STATE OF NORTH CAROLINA
DEPARTMENT OF TRANSPORTATION

June 26, 2015

SUBJECT: **Request for Modification to the Section 404 Individual Permit and Section 401 Water Quality Certification** for the proposed Greensboro Eastern Loop from US 70 Relocation to SR 2303 (Lawndale Drive), Guilford County, Division 7. WBS Element No. 34821.1.1, TIP Nos. U-2525B and U-2525C.

**PERMIT DRAWING
SHEET 32 OF 93**

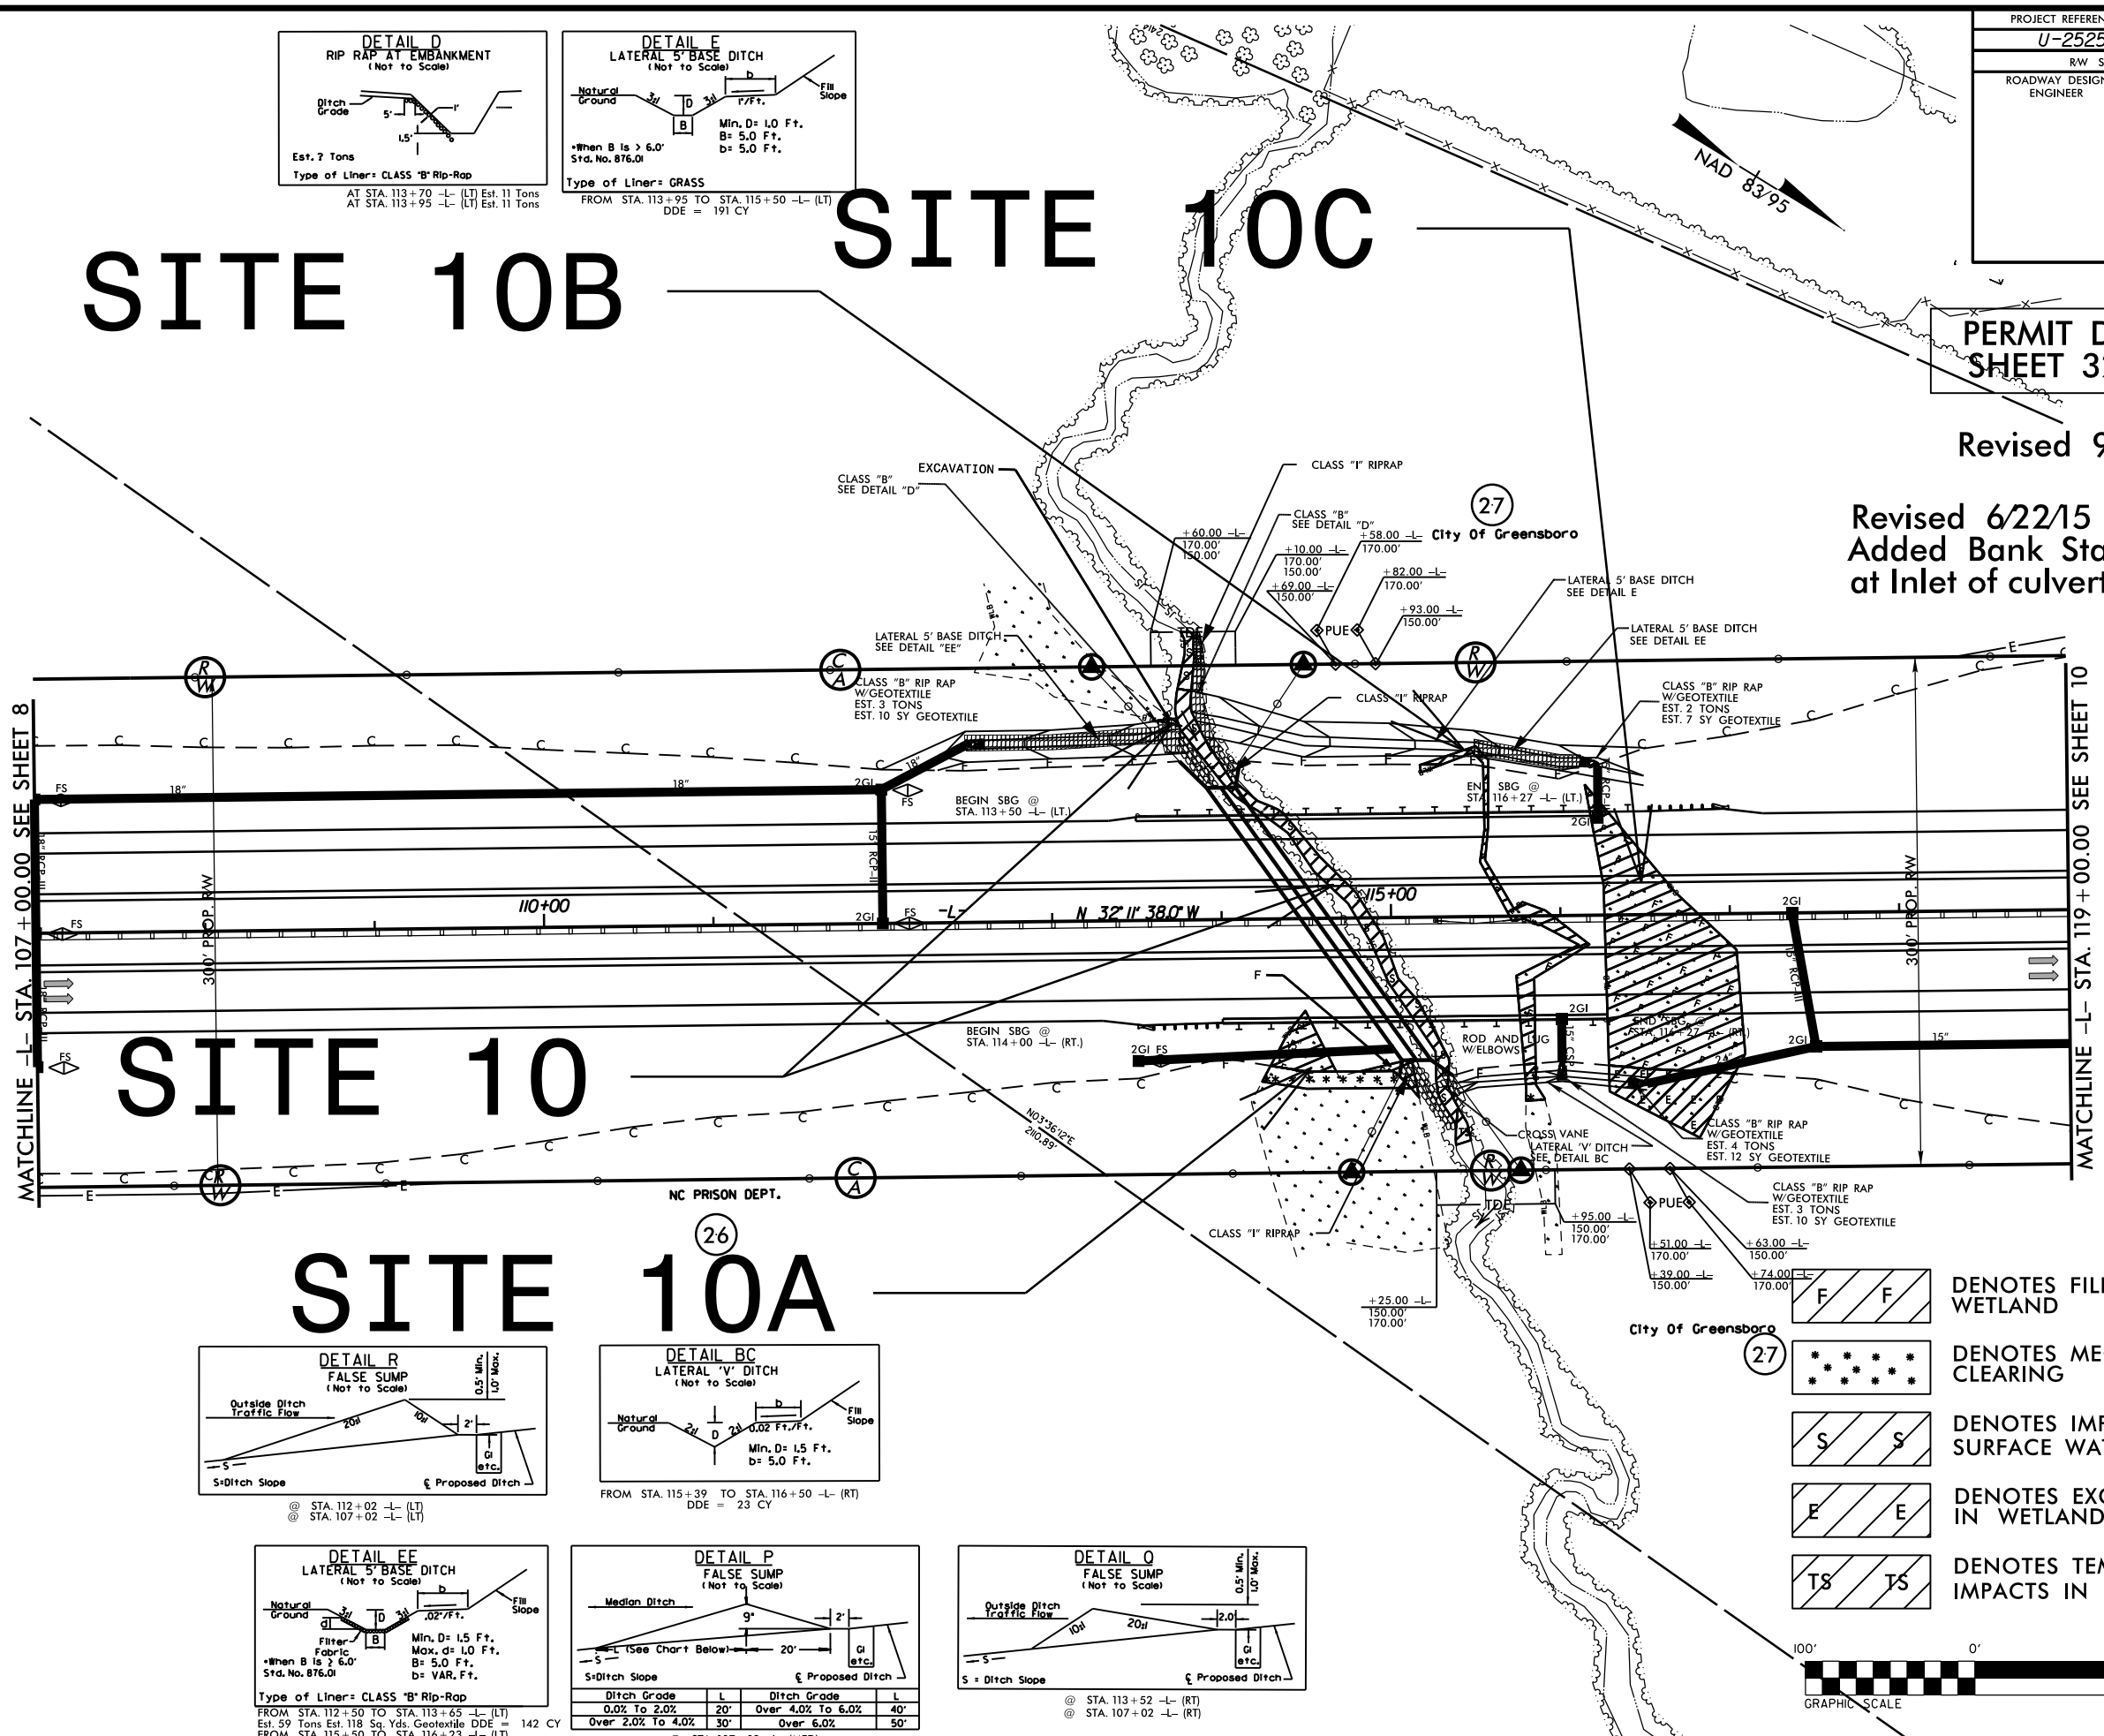
Revised 6/22/15
Added Bank Stabilization
at Inlet of culvert (Site 10)

**PERMIT DRAWING
SHEET 33 OF 93**

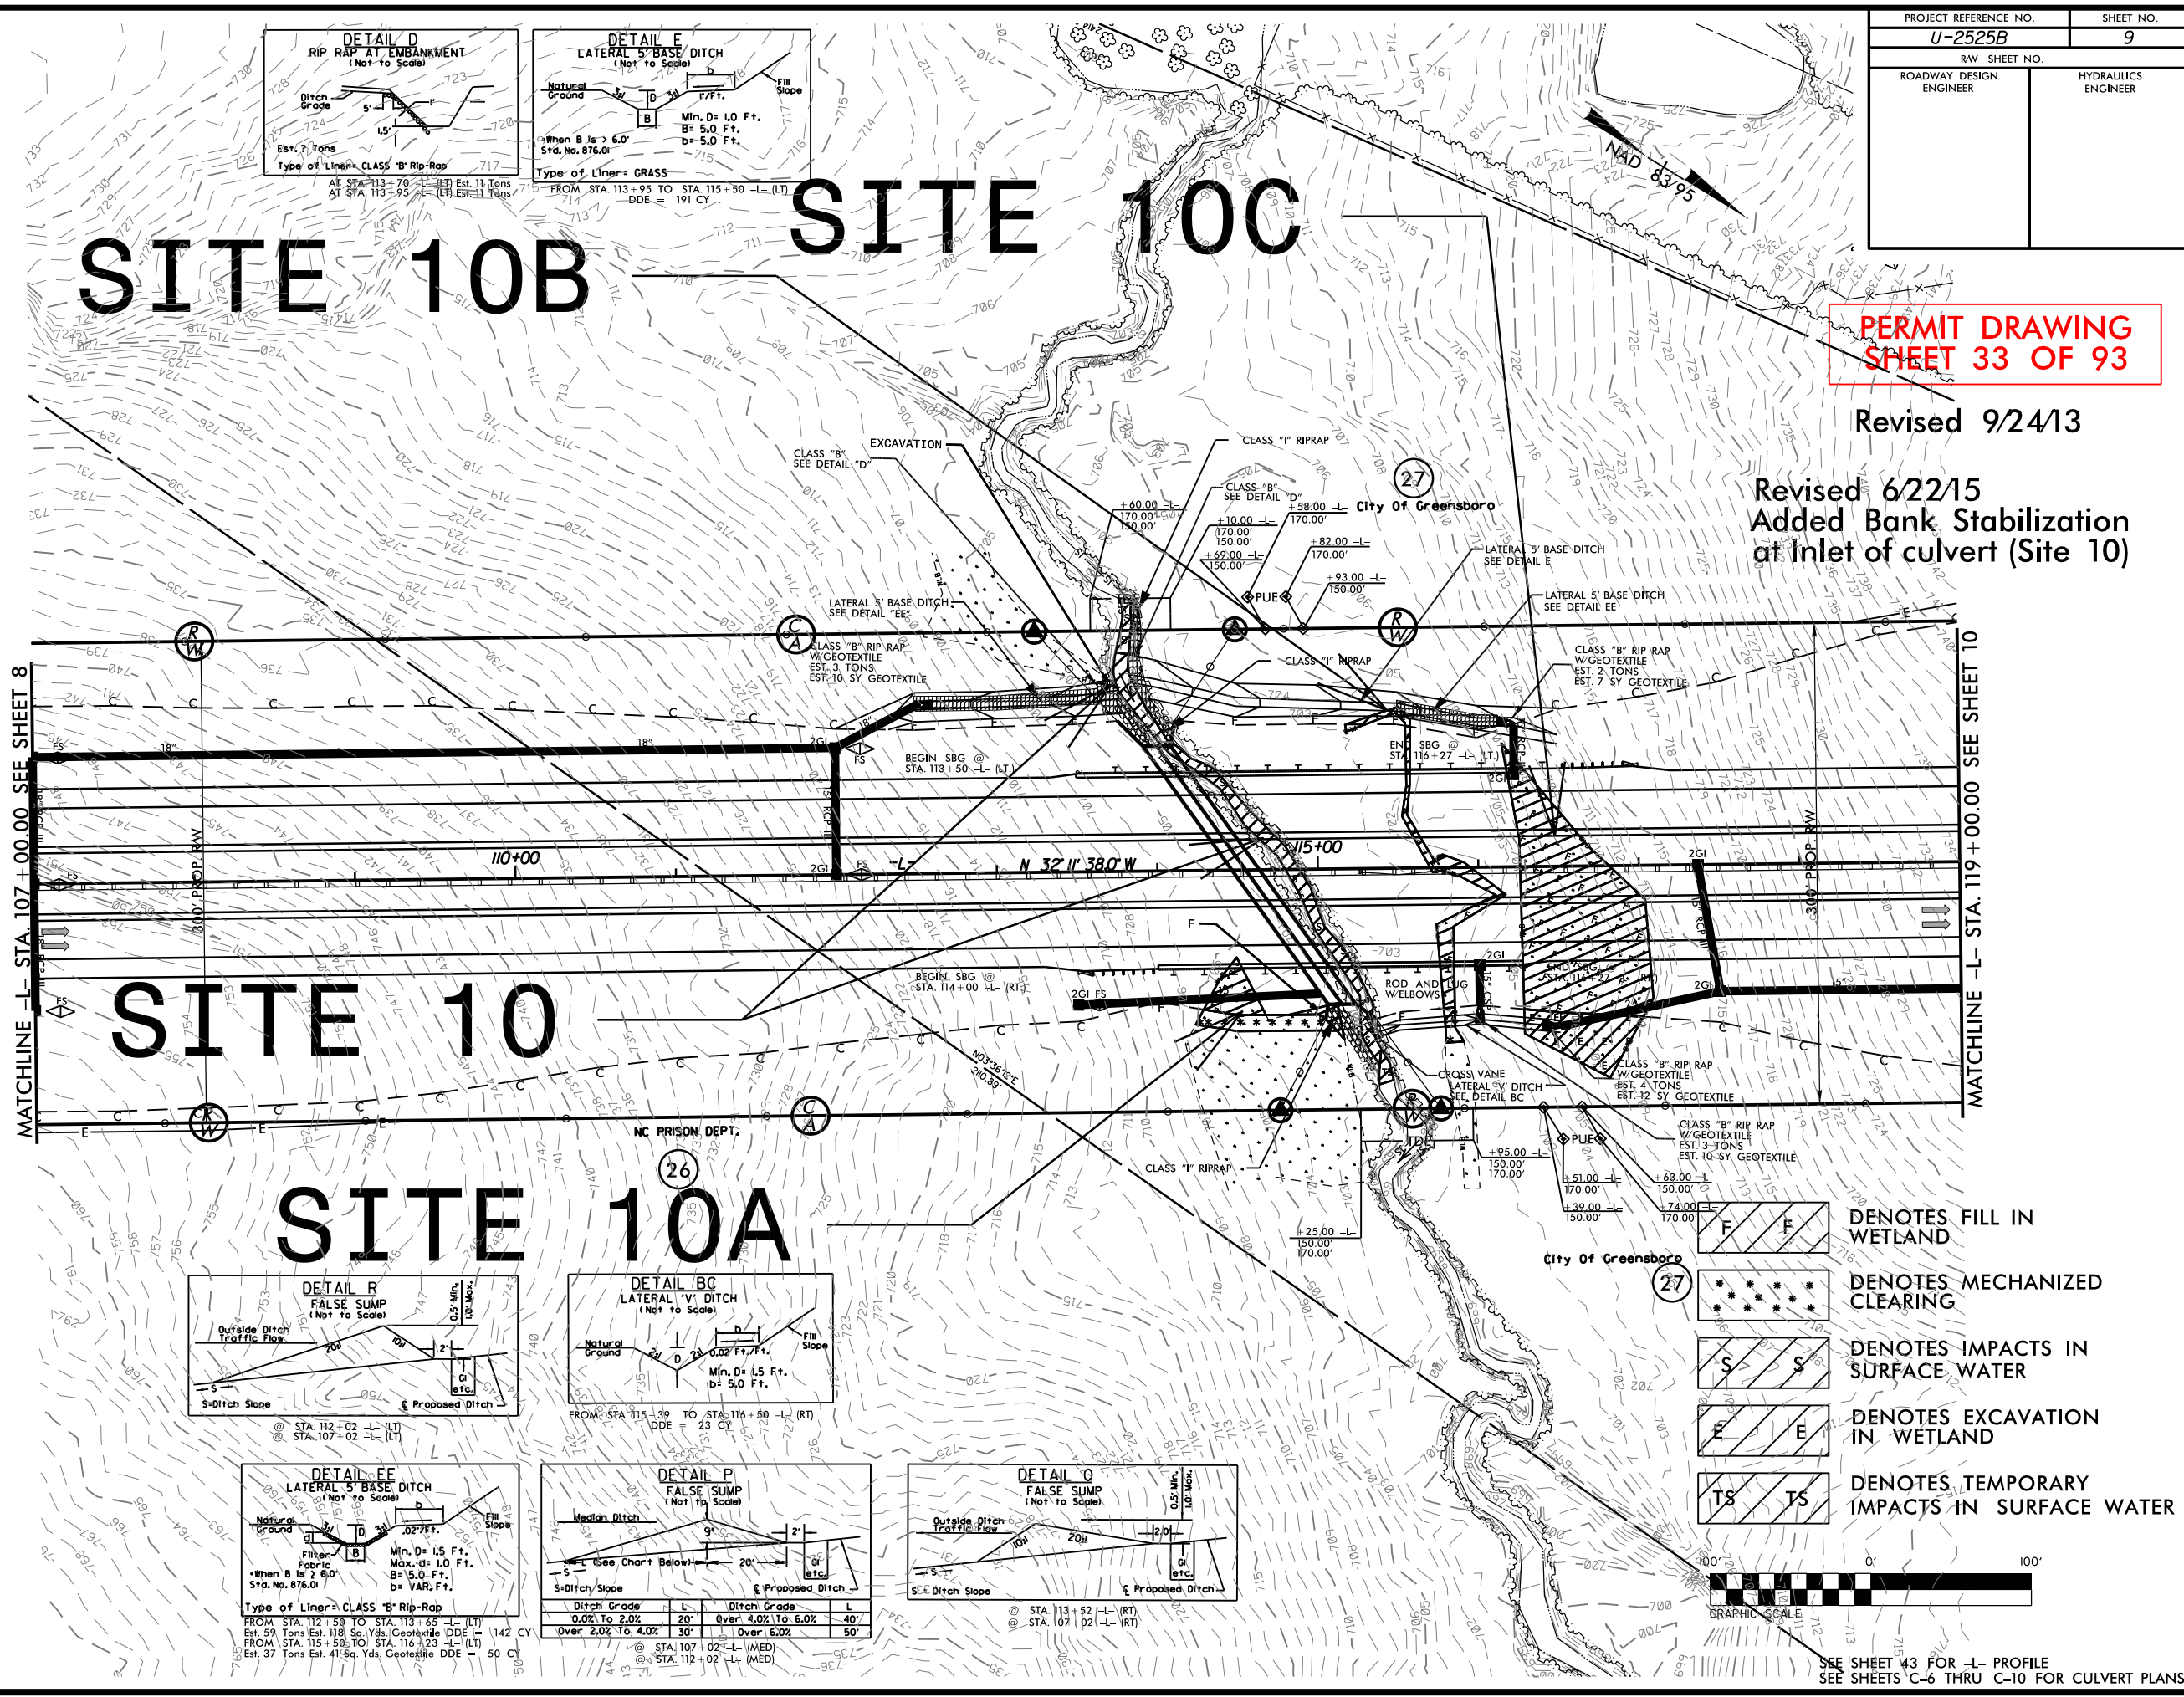
Revised 6/22/15
Added Bank Stabilization
at Inlet of culvert (Site 10)

PERMIT DRAWING
SHEET 54 OF 93
Revised 06/22/15

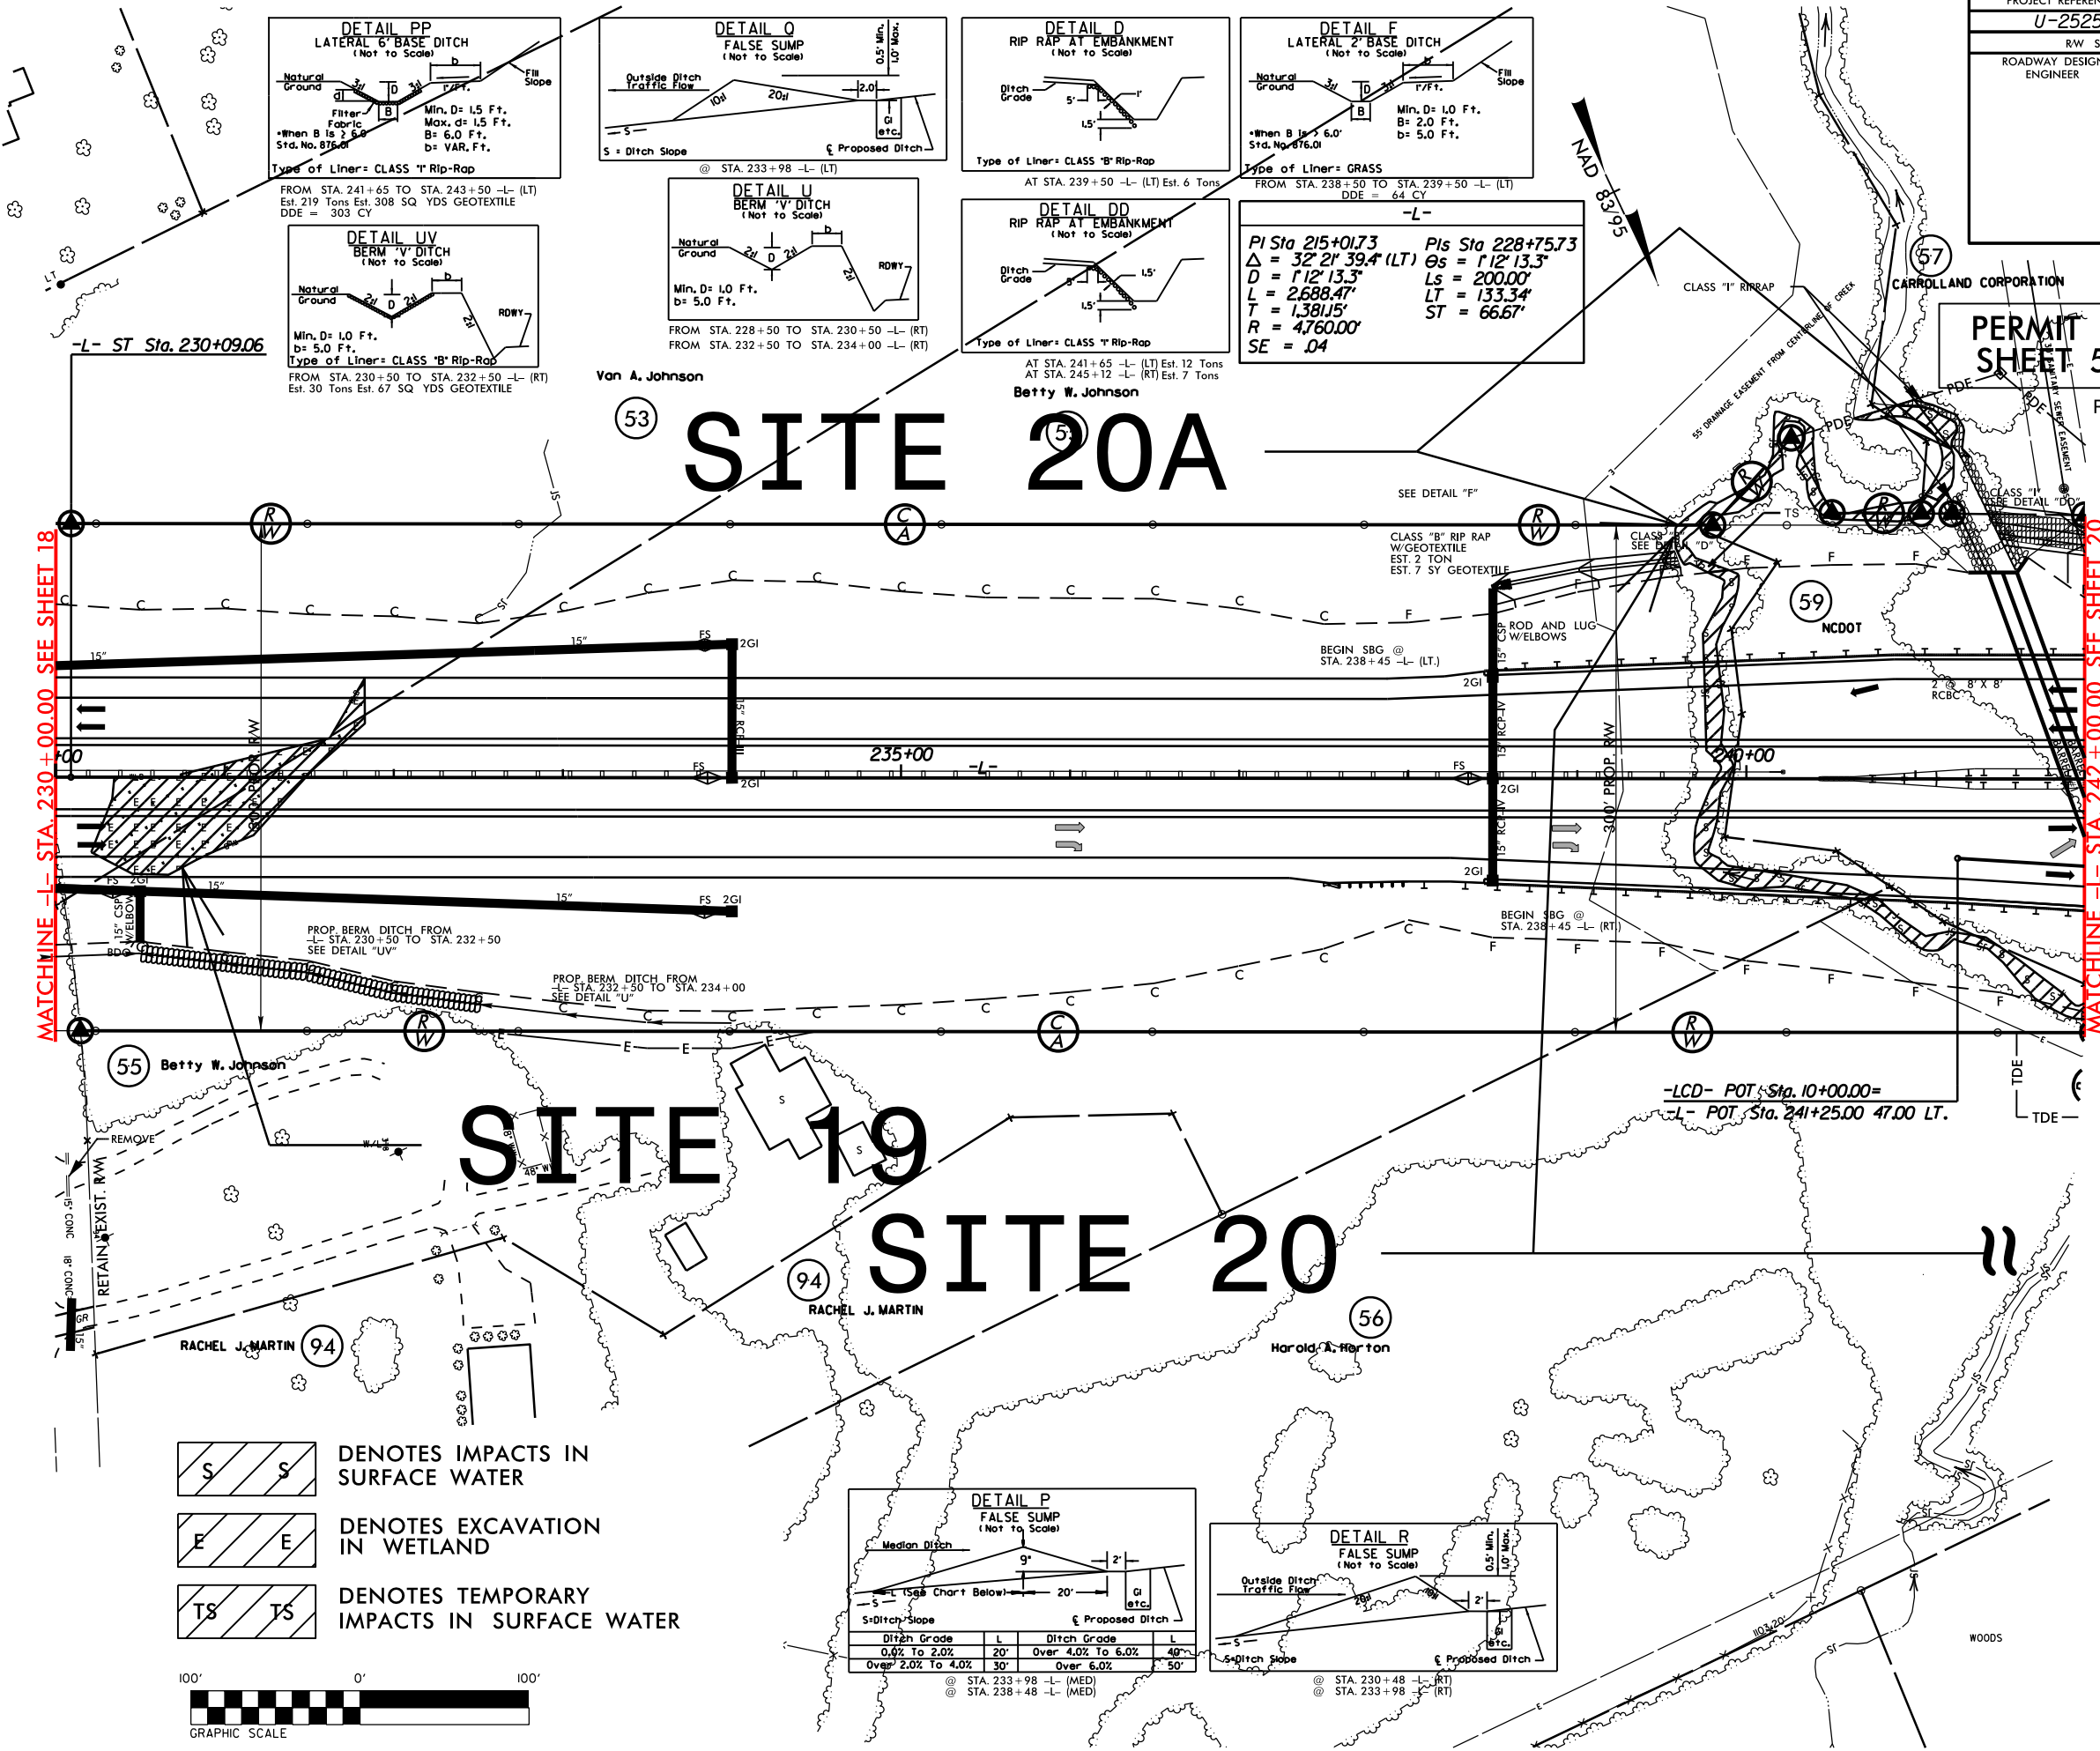
Additional streambank stabilization will also be necessary for Permit Site 10 (35 additional linear feet, offsetting 14 linear feet of temporary impact) and Permit Site 20A (79 additional linear feet, offsetting 29 linear feet of temporary impact). Please refer to the attached revised sheets 32, 33, 54, 55, 79, and 80 for the revised Permit Sites 10, 20A, 31 and 32A impacts. Table 1 below and the attached revised summary table (Sheets 87-93 of 93) have been revised to reflect these revisions.
